SERVICE LETTER

No. 675

Magneto Switch Guard Installation

PA-31 and PA-31-300 Navajo
PA-31-350 Navajo Chieftain
PA-31P Navajo

● PA-31 AND PA-31-350

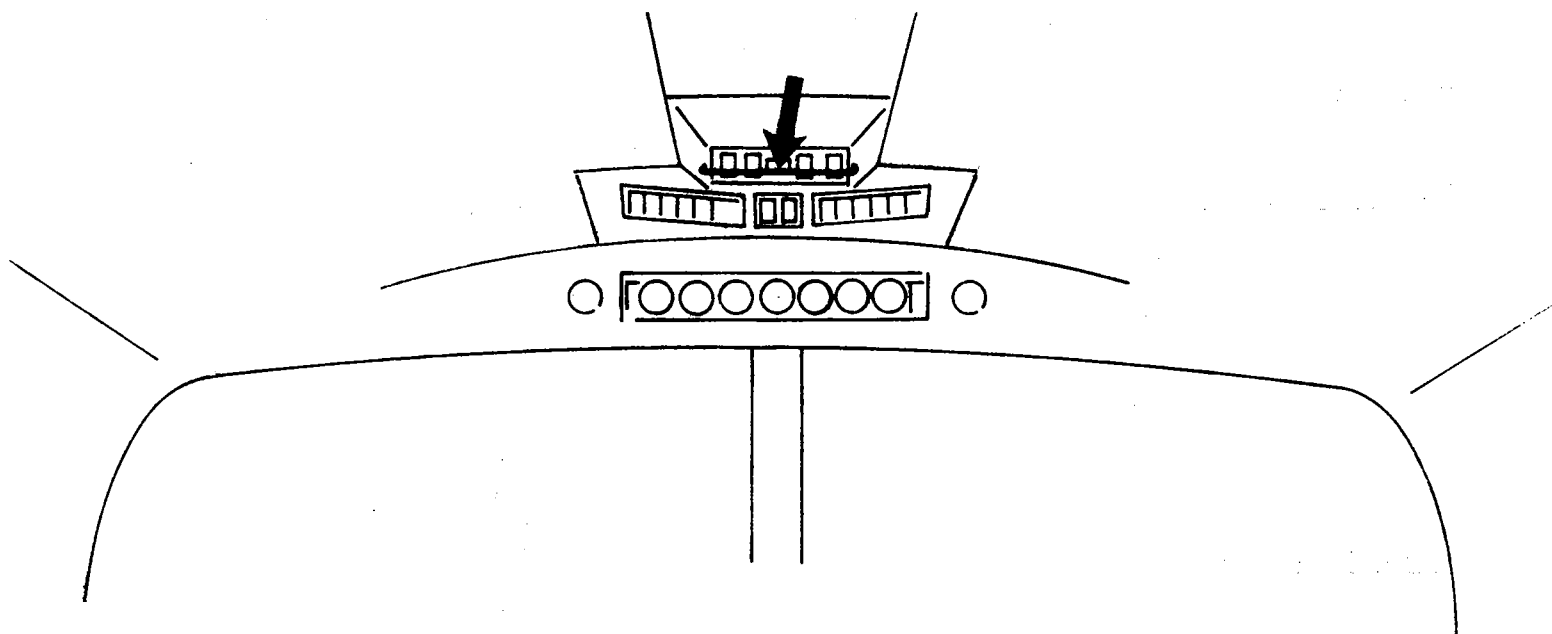
To announce the availability of field installation kits containing material and instructions to install a protective barrier across the face of the magneto switches on the above referenced aircraft.

The magneto switches on the Navajo Series aircraft are located on the overhead instrument panel and are "rocker" type switches. Installation of the subject switch guards will assist in preventing inadvertent magneto switch shut-off. Refer to sketch on reverse side of this letter for a general illustration of the switch guard installation.

1. PA-31 and PA-31-300 Navajos and PA-31-350 Navajo Chieftain -- reference Serial Numbers Affected, above; one (1) each per aircraft Magneto Switch Guard Installation Kit, Piper Part No. 760 789, at \$3.76A suggested retail unit price.
2. PA-31P Navajo -- reference Serial Numbers Affected, above; one (1) each per aircraft Magneto Switch Guard Installation Kit, Piper Part No. 760 790 at \$1.94A suggested retail unit price.
